Inland Transport Committee

World Forum for Harmonization of Vehicle Regulations**Working Party on Passive Safety****Fifty-sixth session**

Proposal for a new Regulation on Frontal Impact**Proposal of amendments to the draft new Regulation
(ECE/TRANS/WP.29/GRSP/2014/10)****Submitted by the expert from France as Chair of the Informal Working
Group on Frontal Impact***

Model B

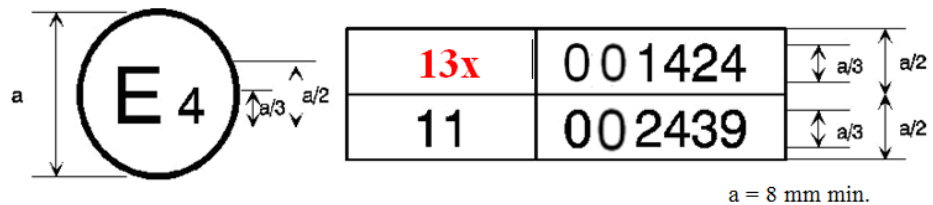
The above approval mark affixed to a vehicle shows that the vehicle type concerned has been approved in the Netherlands (E 4) pursuant to Regulations Nos. **13x** ~~{X}~~ and 11¹. The first two digits of the approval numbers indicate that, at the dates when the respective approvals were granted, Regulation No. **13x** ~~{X}~~ incorporated the **020** series of amendments and Regulation No. 11 incorporated the **020** series of amendments."

Figure 1

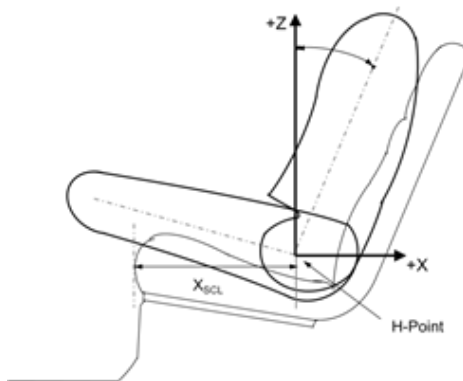
The longitudinal and vertical dimension of "H" point are described as (X_{50thM}, Z_{50thM}) and the longitudinal and vertical dimension of "H 5th" point are described as (X_{5thF}, Z_{5thF}). XSCL is defined as the horizontal distance between the "H" point and the most forward point on the seat cushion (see Fig. 1). The following formula calculates the "H 5th" point. Note that X_{5thF} should always be more forward than the X_{50thM}.

$$X_{5thF} = X_{50thM} + (93mm - 0.323 \times XSCL)$$

$$Z_{5thF} = Z_{50thM}$$

Figure 2

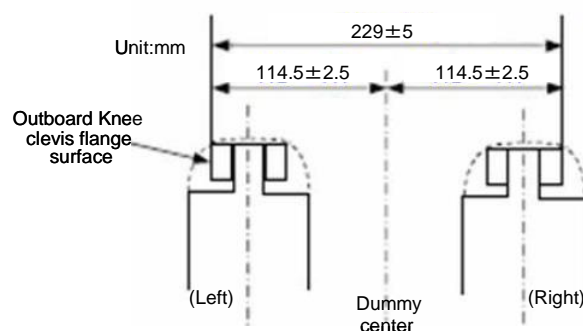
The upper legs of the passenger test dummy shall rest against the seat cushion to the extent permitted by placement of the feet. The initial distance between the outboard knee clevis flange surfaces shall be ~~[270 mm ± 10 mm]~~ **229 mm ± 5 mm** as shown in Figure 2. To the extent practicable, both legs of the passenger dummy shall be in vertical longitudinal planes. Final adjustment to accommodate placement of feet in accordance with paragraph 3.6. for various passenger compartment configurations is permitted.

Fig.(a)

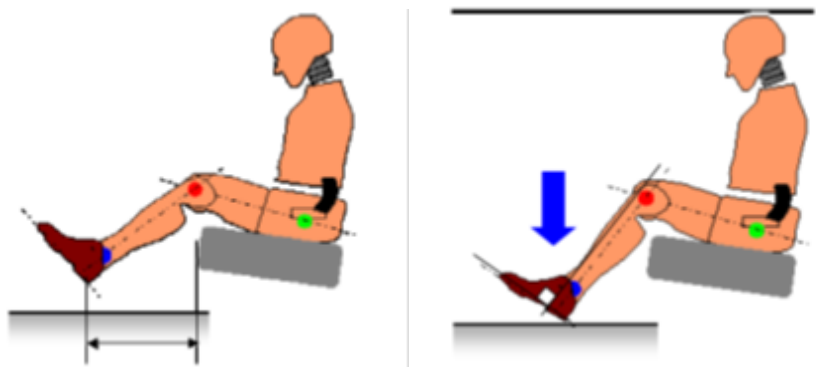
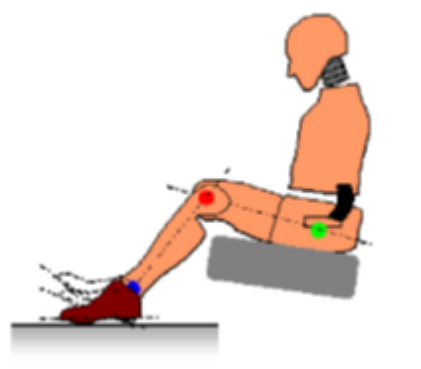
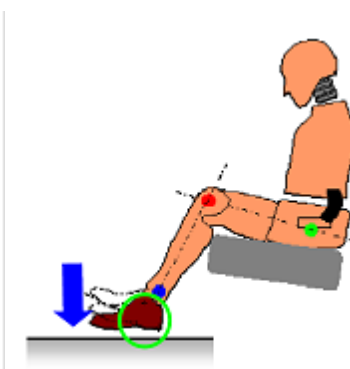
3.6.1. The heels of both feet of the passenger test dummy shall be placed as far forward as possible and shall rest on the floor pan. Both feet shall be positioned as flat as possible on the toe board. The longitudinal centreline of the feet shall be placed as parallel as possible to the longitudinal centreline of the vehicle.

The legs shall be positioned as far as possible from the front end of the rear seat cushion while the thighs are kept in contact with the seat cushion as shown in Fig.(a). As shown in Fig.(b), each leg shall be lowered until the foot comes in contact with the floor while the foot and tibia are kept at a right angle to one another and the thigh inclination angle kept constant. When each heel is in contact with the floor, the foot shall be rotated so that the toe comes into contact as much as possible with the floor as shown in Fig.(c).

If it is not possible to have each foot in contact with the floor, the foot shall be lowered until the calf comes in contact with the front end of the seat cushion or the back of the foot comes in contact with the vehicle interior. The foot shall be kept as parallel as possible to the floor as shown in Fig.(d).

In case of interference by a vehicle body protrusion, the foot shall be rotated as minimally as possible around the tibia. In case interference still remains, the femur shall be rotated to resolve or minimize the interference. The foot shall be moved inward or outward while the separation distance between the knees is kept constant.
